SEXTON CONSULTING

ADDITIONAL INFORMATION

REGISTER REF.: **SD22A/0081**

LOCATION: Kingswood Farm, Moneenalion Common Lower, Kingswood, Dublin 22

Fig.8: 'Members Bar' First Floor Area Calculation

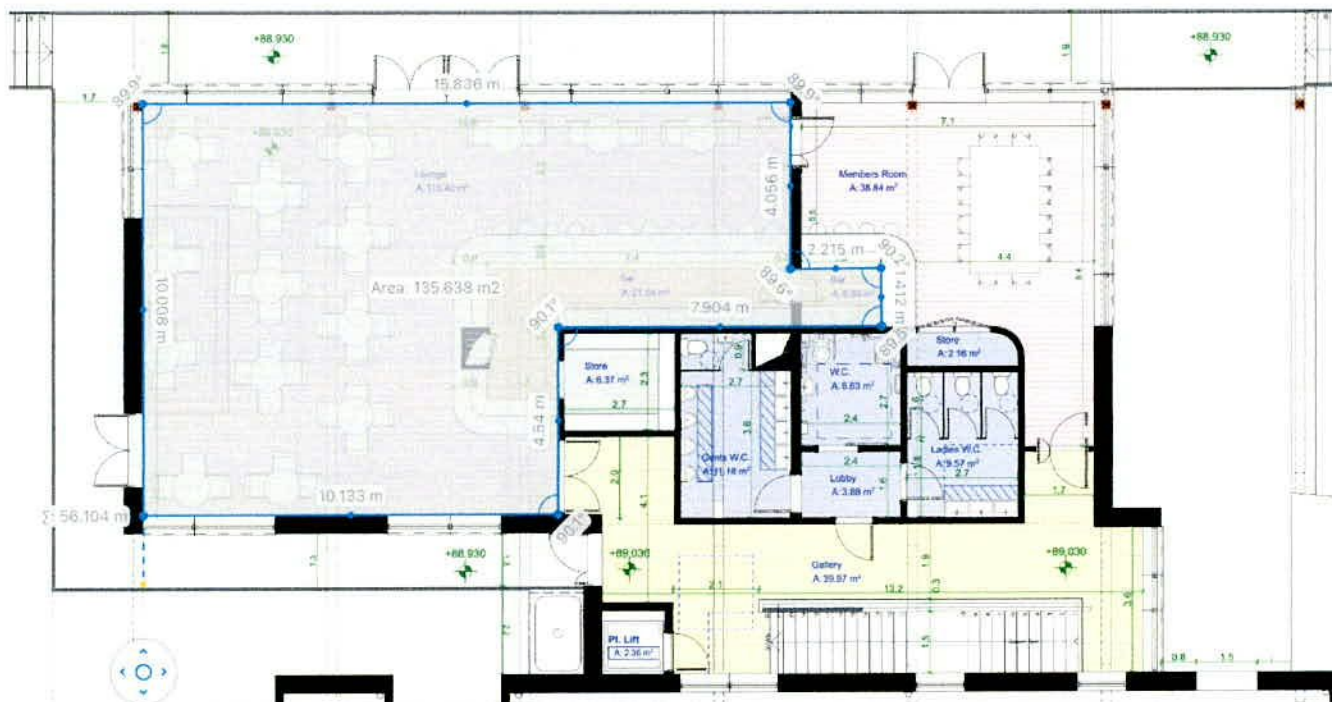
The proposal does not include a justification for the Members Bar in the information submitted to the Planning Authority. Therefore, the applicant is requested to submit information demonstrating a clear justification for the Member Bar.

The area of the existing Member's Bar in Gordon Park is approximately 126 sqm whereas the area of the proposed Member's Bar at Kingswood Farm is calculated as 136 sqm (Refer Fig.8). Therefore, it is designed to be of a similar size (albeit 8% larger) and as such it still represents less than 22% of the Proposed new Clubhouse Pavilion floor area being developed and less than 15% of the developed area when considered as a

portion of the Changing Rooms Building and Clubhouse Pavilion together. So, it is of a relatively small scale which is as it such be being ancillary to the proposed overall Sports and Recreational Facility use.

Fig.A1: PROPOSED PEDESTRAIN STAIRS ACCESS OFF R136: (SCALE 1/200 @A4)

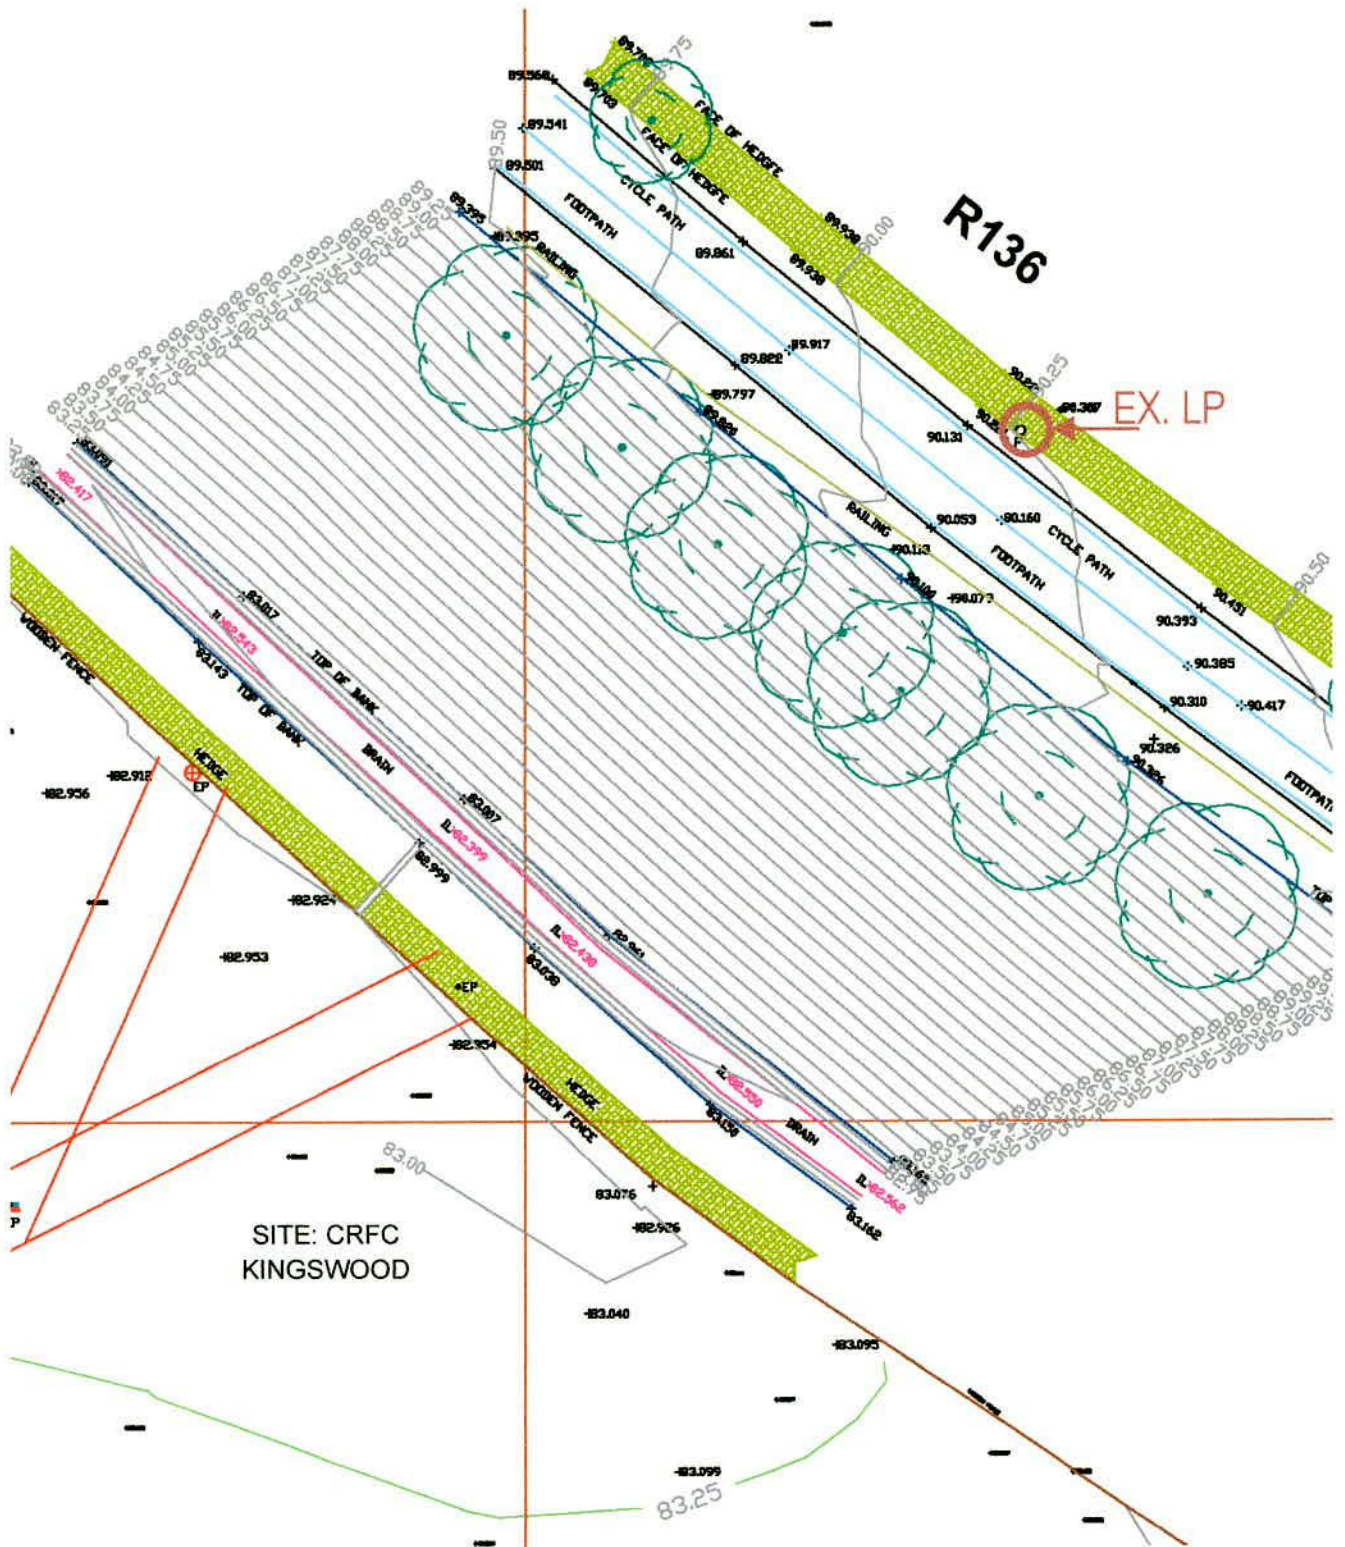
(1) *details/drawing of proposed stairs specification (materials, finishes, hand railings, lighting, gate, gradients, etc).*

(a) *Plan drawing, section drawing and structural drawings (including rebar schedules where applicable).*

(b) *Preventive railing at top of stairs (Noting the 7m level difference between top and bottom).*

The Pedestrian Access Stairs, on the other hand, must overcome a more significant level difference which is indeed just over 7m vertically. The stairs are also detailed in the bound A3 design set, specifically on Drawing Nos. A.03.05.1.3 and A.03.05.1.4 where it is shown in Plan, Sections and Perspective Views. Details of finishes, hand railings, landings, areas of tactile pavement etc are included.

To achieve a safe pitch for the Pedestrian Access Stairs, the R136 embankment earthworks will need to be extended out slightly, and locally, in order to provide proper direct support on new compacted fill material for the proposed new reinforced concrete stair. This embankment extension will be done using stepped benches in strict accordance with Transport Infrastructure Ireland's (TII) Standard Construction Details ref. CC-SCD-00608 and a copy of this drawing is included in Appendix B for ease of reference. There will be a number of level landings between flights, including top and mid-level rest area landings. The stair flight structure will include a formed RC key at the base of each RC flight, to effectively fix them in place.

At ground level on the CRFC site side there is an unlined drainage ditch feature at the toe of the embankment just outside the site boundary fence. With the local outward extension of the embankment this drainage feature will also need to be piped for the width of the extended embankment as shown on Drawing Nos. A.03.05.1.3 and A.03.05.1.4.

Fig.A2: PROPOSED CYCLE TRACK STAIRS ACCESS OFF R136:

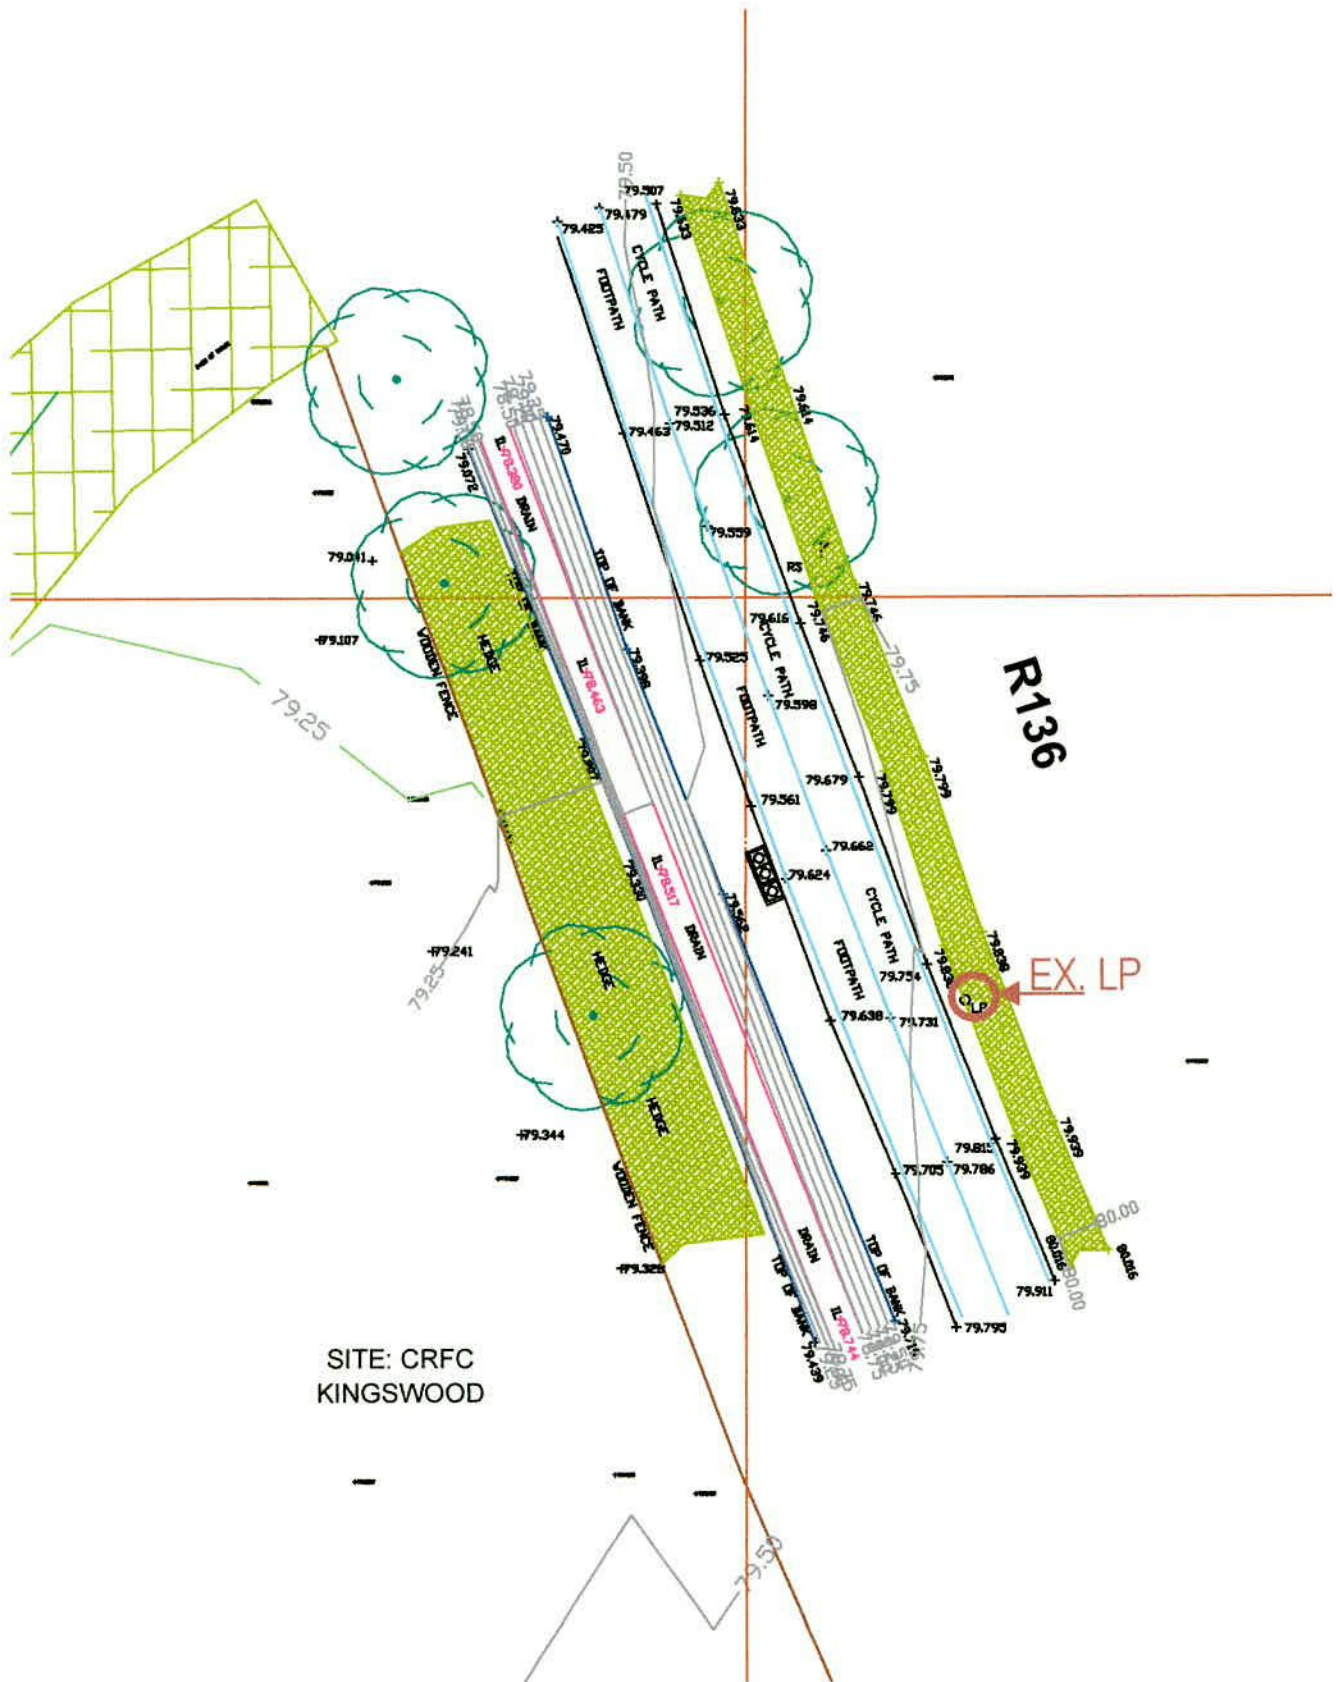
(2) *Further detail regarding proposed cycle track/entrance:*

(a) *Public lighting to be provided along any darkened sections of path, subject to consideration of ecological impacts.*

The proposed Cycle Access Entrance is detailed in the A3 bound design set of drawings on Drawing No. A.03.05.1.2 where it is shown in Plan, Elevation, Section and Perspective View. This access is near level with the adjacent R136 Cycle Track and Footpath with a nice gentle fall into the site of approximately 1/30 or 3.3%. There is a small, grassed drainage ditch present between the edge of the R136 Footpath and the existing fence boundary at the top of the distributor road embankment. This ditch will need to be traversed here and so we proposed that it is piped locally and in accordance with current drainage design and detailing standards and Civil Engineering good practice. The handrail to the crossing is envisaged as a simple but robust timber railing to guard against the slight resulting change in level.
